# **ANA Garrison at Kunduz Does Not Meet All Quality and Oversight Requirements; Serious Soil Issues Need to Be Addressed**

SIGAR Audit-10-09

April 2010

**Figure 2: Master Plan of Kunduz ANA Garrison, Phase I**

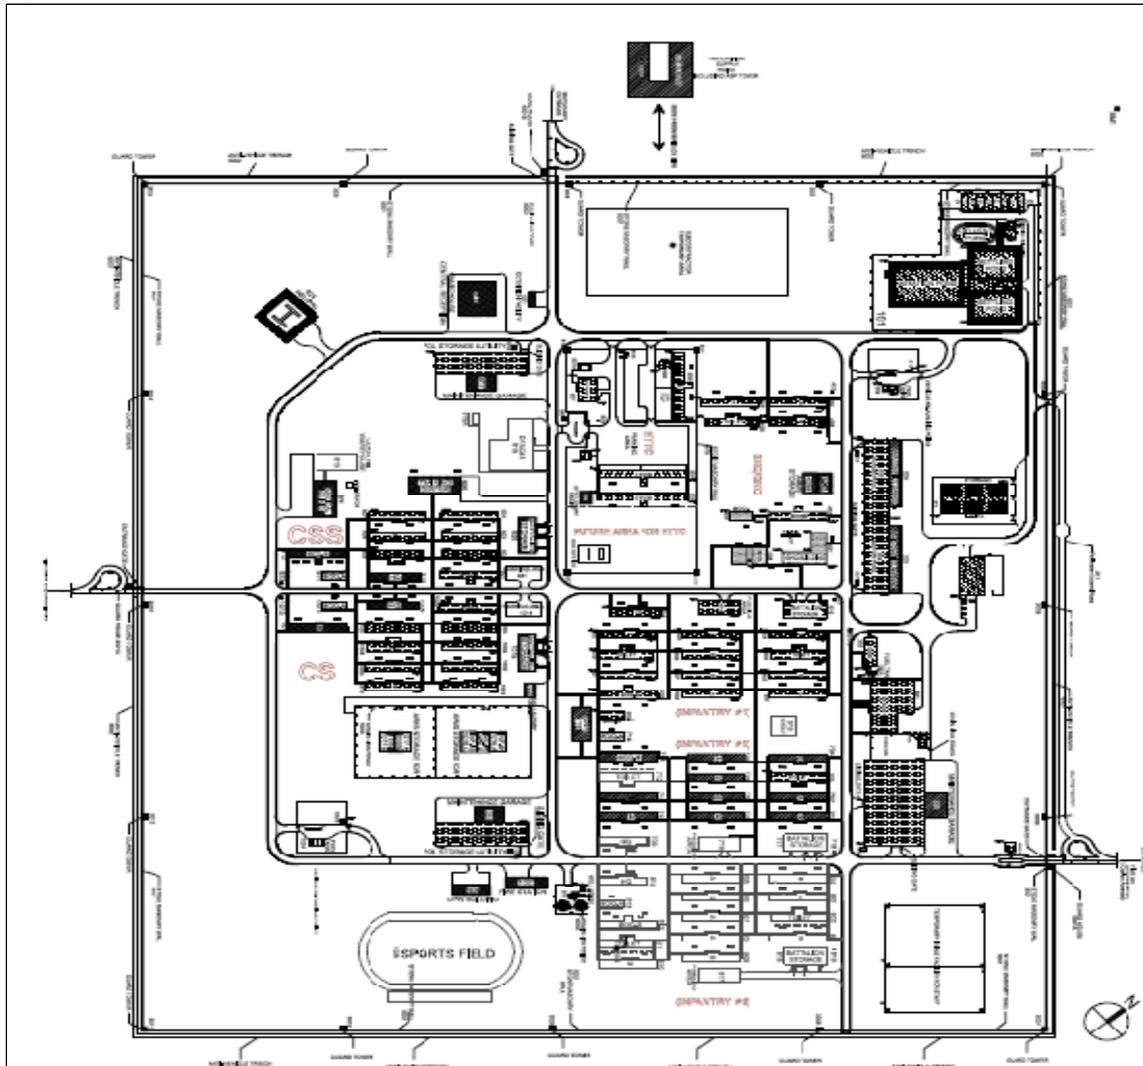
*"As shown in figure 2, the master plan details two phases ...."*

The diagram does not show Phase I and Phase I. Recommend replacing Figure 2 with the diagram that depicts all phases.

5. We modified the report to indicate that the diagram shown in figure 2 does not show Phase II of the Kunduz ANA garrison.
6. We modified the report to indicate that current plans call for housing German soldiers at the embedded training team compound.
